Flange Options for the Antineutrino Detectors

Kirk McDonald

(August 8, 2007)

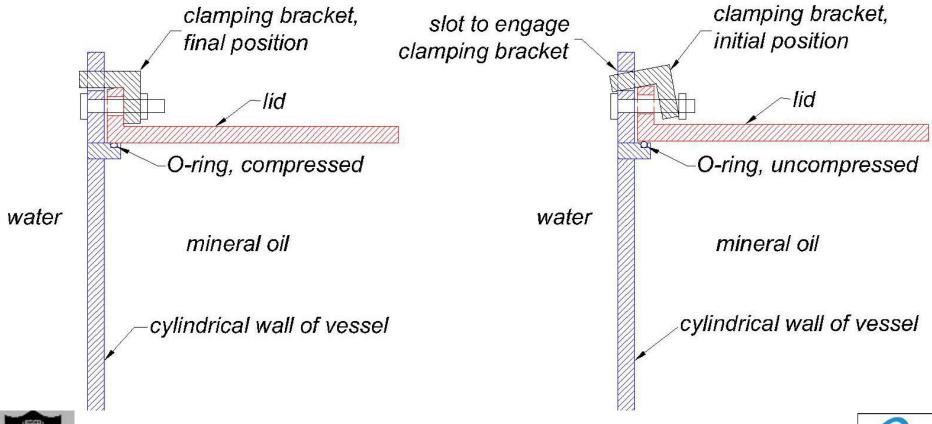
Use horizontal bolts to secure lid to vertical wall of vessel.

If the O-ring needs compression during assembly, use clamping brackets (one per bolt) that engage a slot in the vessel wall such as to force the lid down as the bolts are tightened.

This concept could be applied to both the SS vessel and the outer acrylic vessel.

Stress concentrations in the wall and lid around the flange bolts should be evaluated.

Will the O-Ring Be Compressed by the Weight of the Lid?

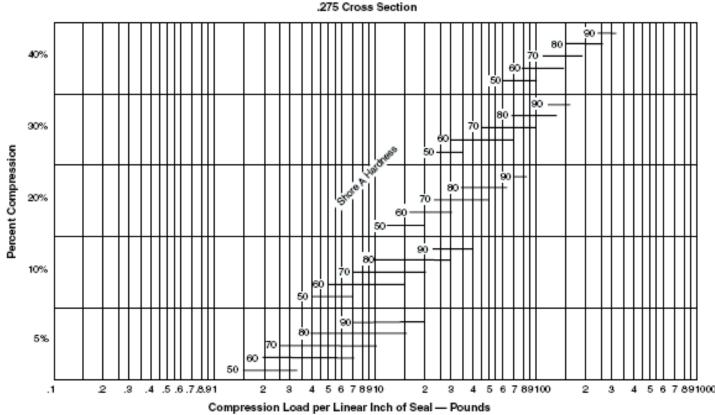
A 0.25"-diameter O-ring of 50 hardness requires 20 lb/in to be compressed by 20%.

- \Rightarrow Need 12,600 lb to compress a 5-m-diameter O-ring (10,000 lb for 4-m-diameter).
- \Rightarrow Since neither the SS lid nor the acrylic vessel lid weigh this much, the O-rings will need to be compressed by the clamping brackets during assembly.
